### STAFF RECOMMENDATION

2111 Natchez Trace

March 18, 2020

**Application:** New Construction—Addition

Figure 2. 1957 Sanborn map.

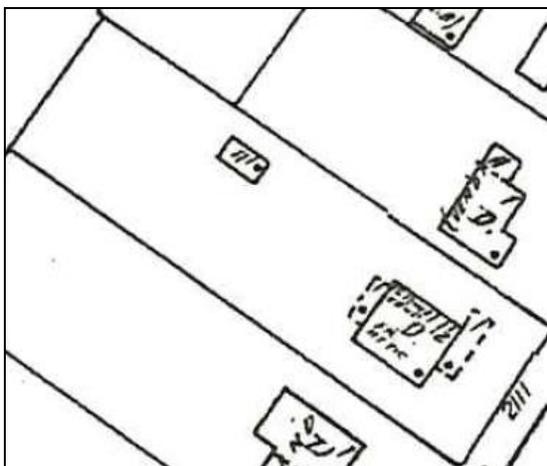
Partial Demolition: The applicant proposes to demolish an existing enclosed rear porch. The 1957 Sanborn map shows a covered rear porch in this location that has since been enclosed (Figures 2 and 3). Given the porch's location at the rear of the house and alterations since 1957, staff finds that the porch is not a character defining feature of the historic house and demolition can be appropriate. No other changes to the historic house are proposed with this application.
